#### Report to the Future Melbourne (Planning) Committee

#### Planning Application: TP-2016-537 109-111 Little Lonsdale Street, Melbourne

#### **DELEGATED PLANNING APPLICATION REPORT**

Application number:	TP-2016-537
Applicant:	Brady Jones Pty Ltd
Address:	109-111 Little Lonsdale Street, MELBOURNE VIC 3000
Proposal:	Proposed demolition of existing building and construction of a residential hotel
Date of application:	4 July 2016
Responsible officer:	Billy Rebakis

PROPOSED NORTH ELEVATION

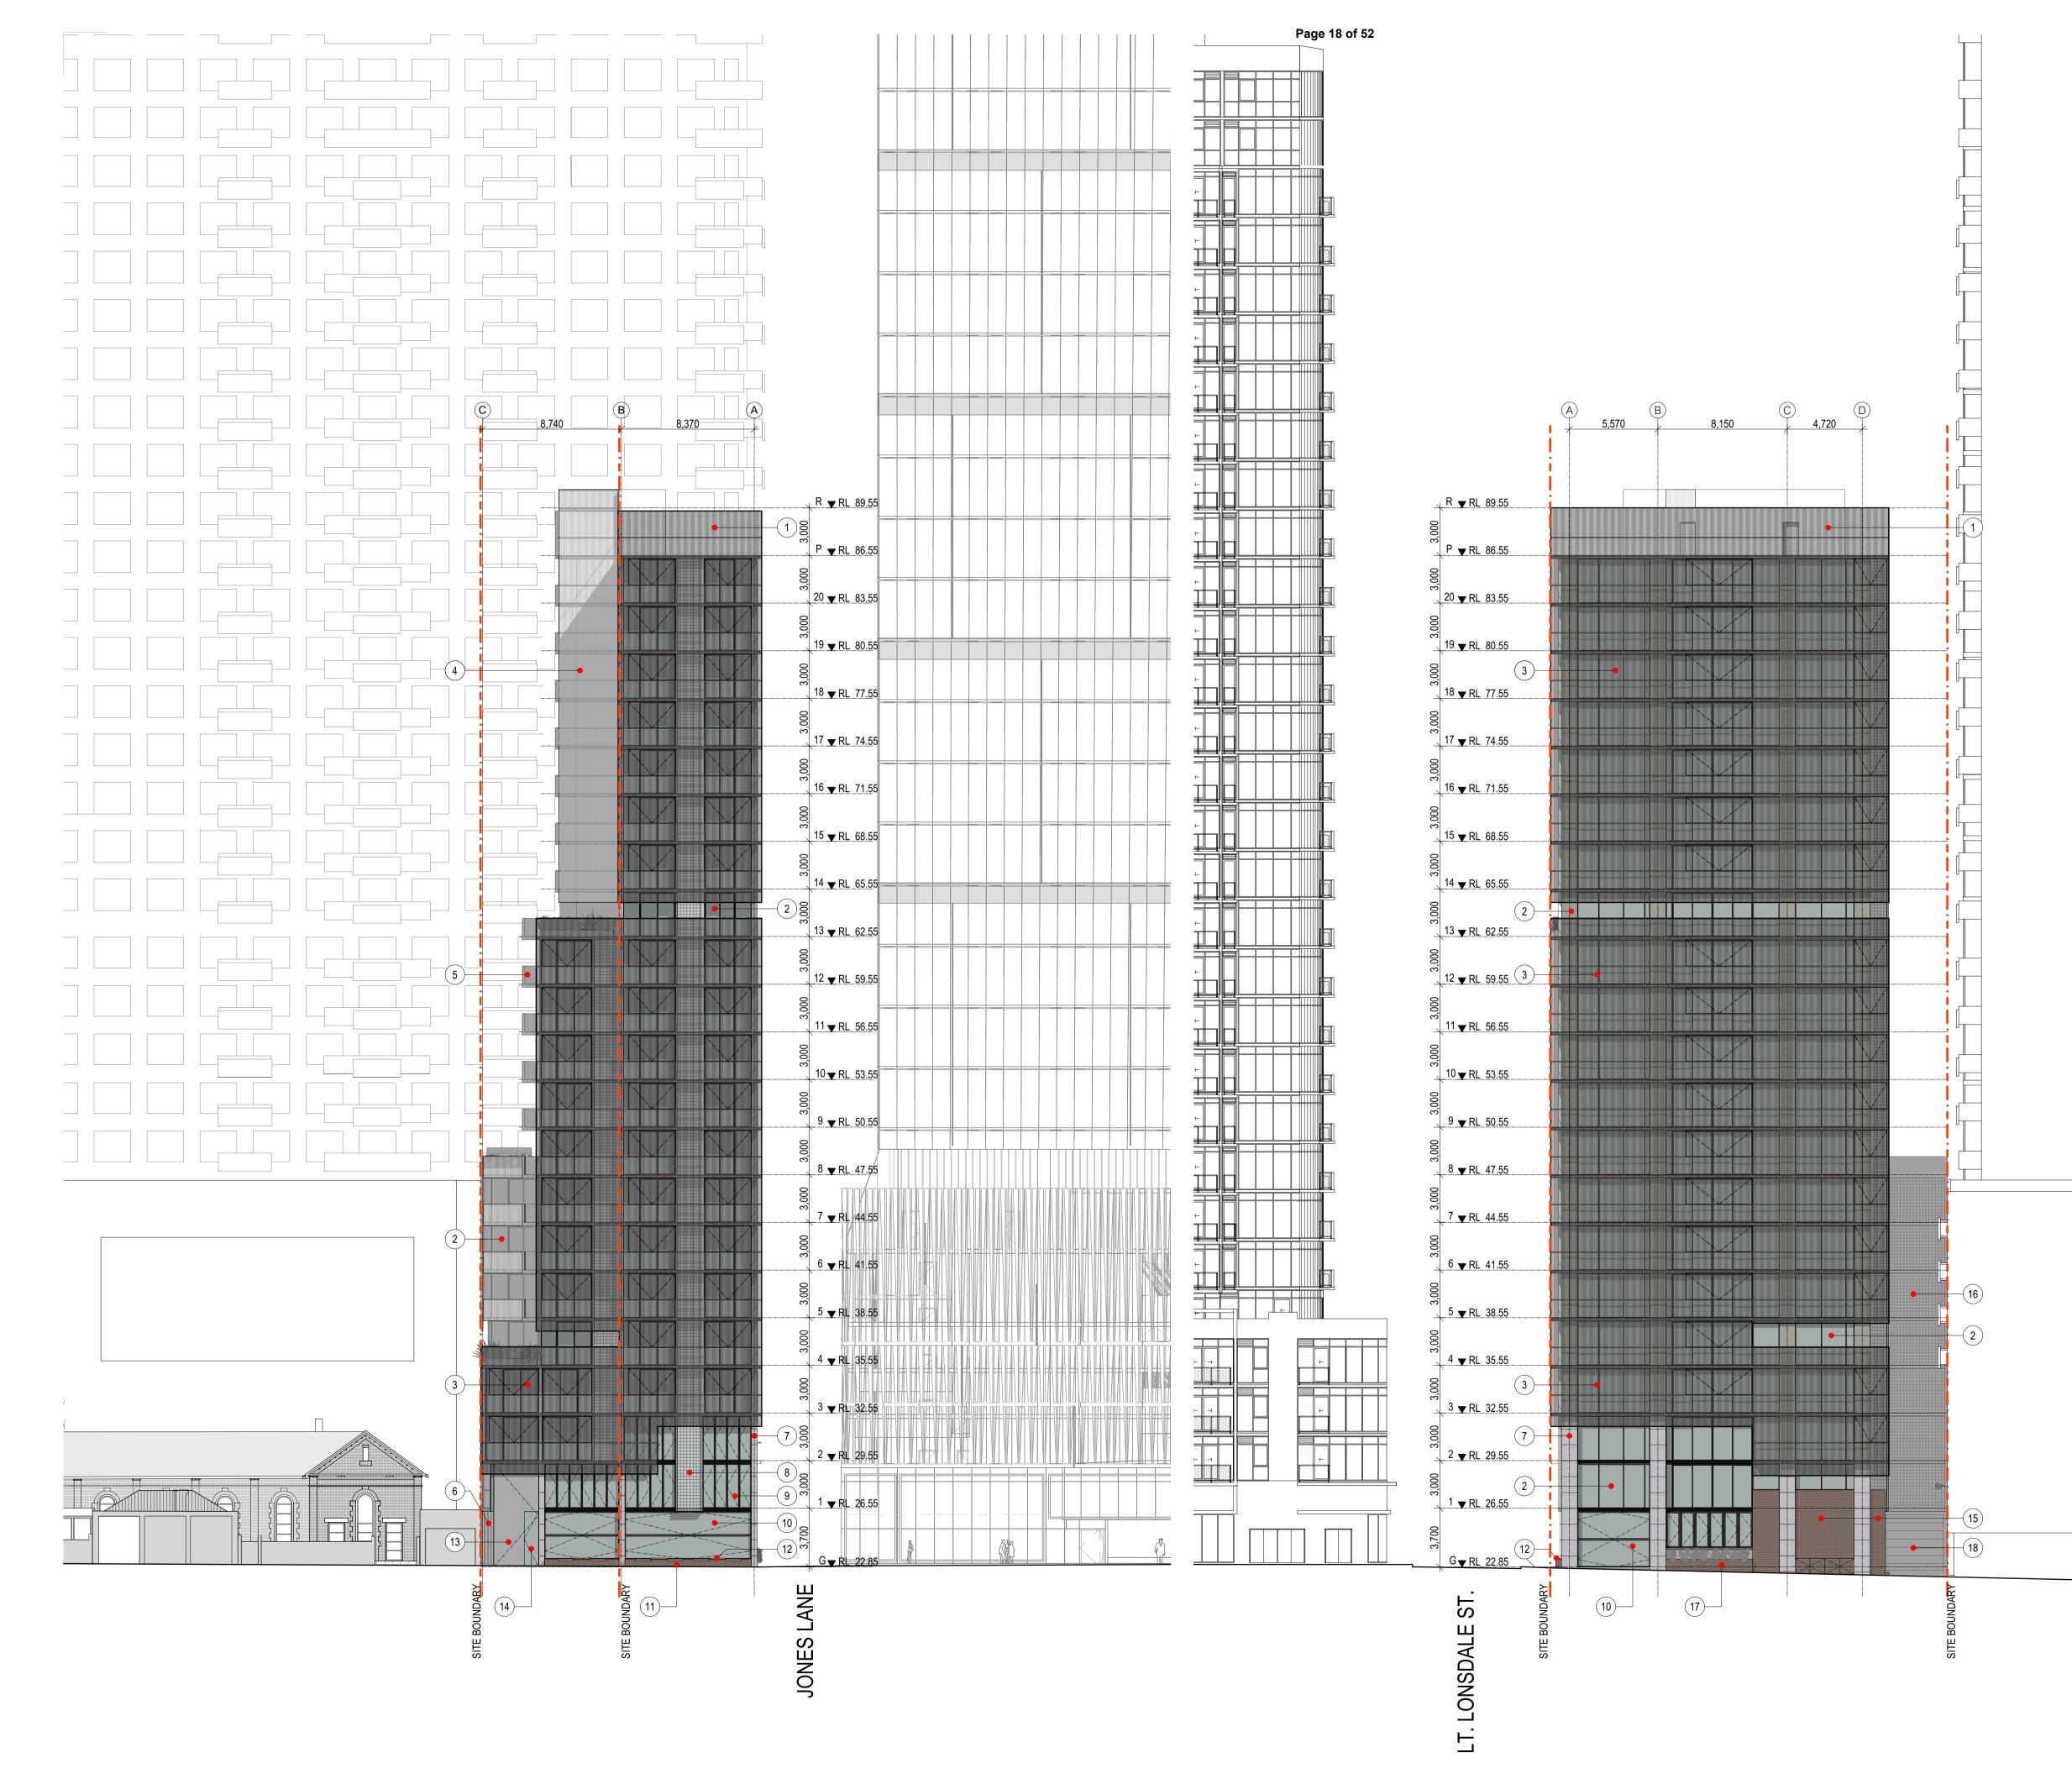
- b) South elevation updated to replace opaque glass blocks with translucent glass blocks
- c) Updated materials legend to confirm aluminium webforge material and delete 'or similar' reference
- d) Delete the deck on level 8 and associated structures.
- e) Any modifications to the plans required by the Waste Management Plan
- f) Minimum vertical clearance of 3.5m provided for the loading bay to Council Lane 0106
- g) Confirmation that direct views into the secluded private open space and habitable room windows of surrounding dwellings within a horizontal distance of 9m are prevented in accordance with the requirements of Standard B22 at Clause 55.04-6 of the Melbourne Planning Scheme
- h) The location of all external plant equipment, including air conditioner units, and details of screening proposed to limit views from public roads.
